**RE: North Country Environmental Services, Inc. - Bethlehem, NH
Stage II - Phase I Construction**

Re: North Country Environmental Services Landfill
Bethlehem, New Hampshire

**STAGE II - CONSTRUCTION
 REVISED LINER CONNECTION DETAIL**

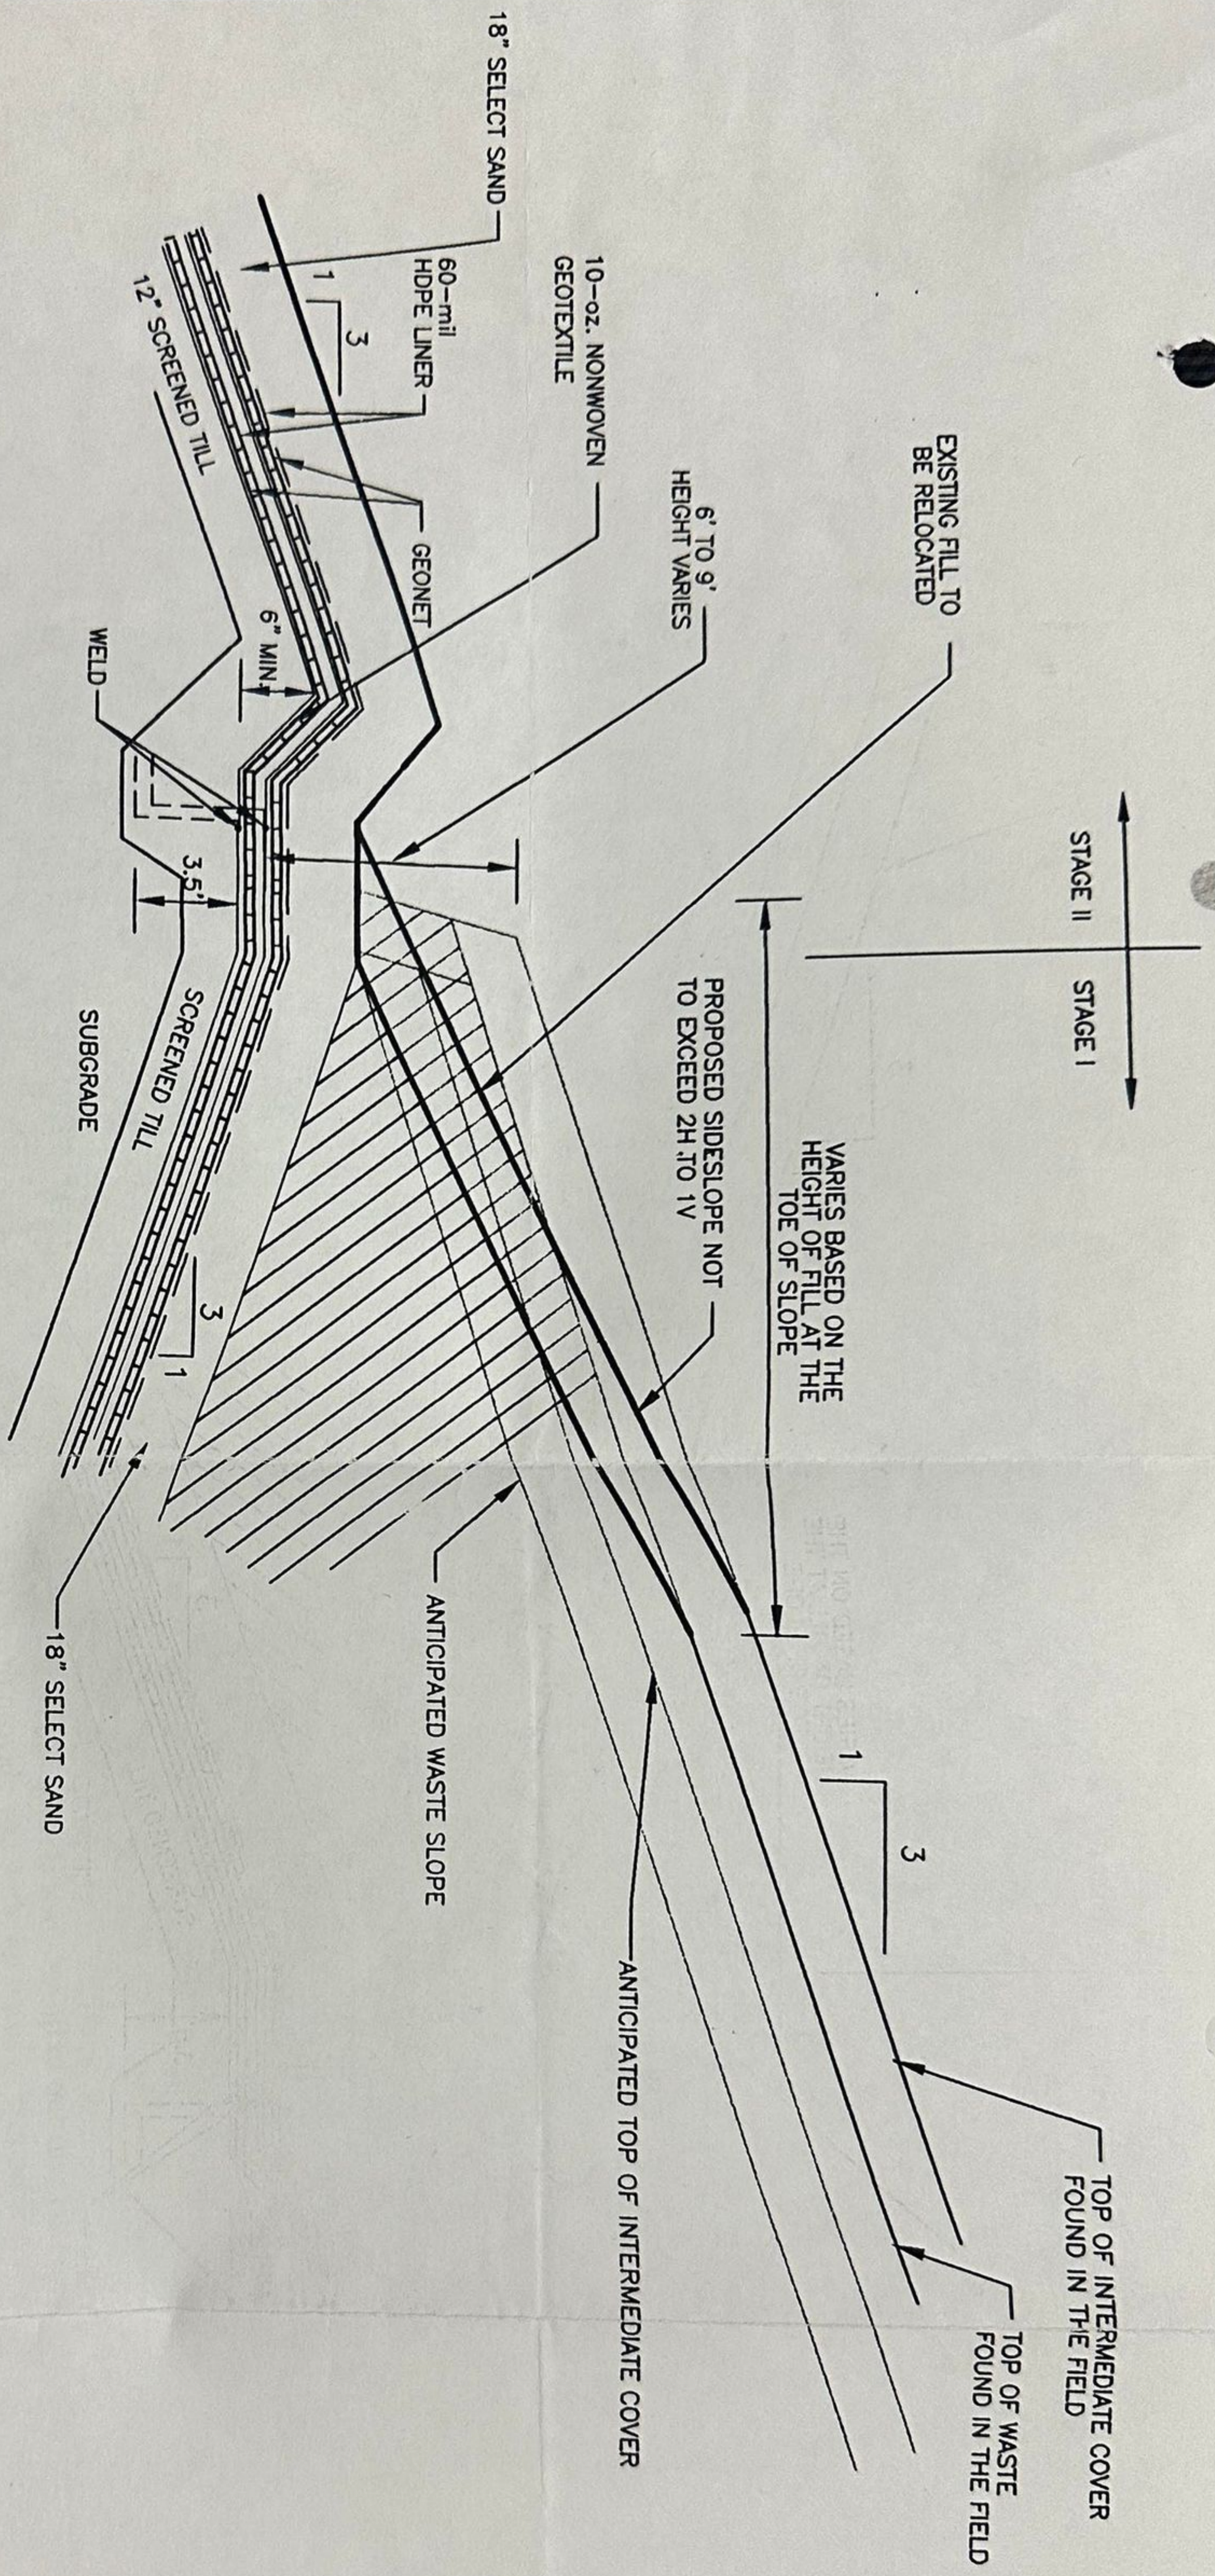
At your request we have prepared this letter describing conditions encountered during excavation to expose the Stage I liner anchor trench along the common bound between Stages I and II, and presenting our recommendations to complete the Stage I/II liner connection. During excavation to locate the anchor trench it was determined that additional fill had been placed on a portion of the east Stage I sideslope such that waste fill had been placed above that portion of the liner at the top of the berm extending from the inside crest of the berm to the anchor trench. Staining was noted beyond the edge of the liner in certain areas indicating that leachate had discharged beyond the liner as a result of this condition. We understand that this portion of the facility had been filled, generally in the late 1980s, by prior owners of the facility. Shortly after exposing the liner, the contractor took steps to excavate additional material along the anchor trench to contain leachate within the lined facility.

At your request, we modified the Stage I/II liner connection detail (detail No. 2 on Sheet 9 of the design plans) to reflect conditions encountered in the field. Our recommended modification is attached as Figure 1. As indicated on Figure 1, we recommend that the existing fill slope be graded to slope not steeper than 2 horizontal to 1 vertical (2H:1V) upward from a point inside the top of the liner on the berm to meet the existing 3H:1V slope. A minimum of 12 inches of intermediate cover should be placed over the excavational material.

To provide an additional measure of containment, we recommend that the liner connection detail be modified so that the Stage II liner system rises up a minimum of 6 inches from the location where the liners are welded together before dropping to the Stage II landfill base. This small berm will provide a further measure of assurance that leachate will be contained within Stage I.

1. EXCAVATE STAGE I ANCHOR TRENCH TO EXPOSE THE PRIMARY AND SECONDARY LINER AND LEACHATE COLLECTION SYSTEMS.
2. CAREFULLY CUT THE PRIMARY LINER AND FOLD BACK TO EXPOSE SECONDARY LINER.
3. WELD STAGE II SECONDARY LINER TO STAGE I SECONDARY LINER.
4. INSTALL SECONDARY GEONET.
5. WELD STAGE II PRIMARY LINER TO STAGE I PRIMARY LINER.
6. INSTALL PRIMARY GEONET, 10-oz. NONWOVEN GEOTEXTILE AND 18" SELECT SAND.
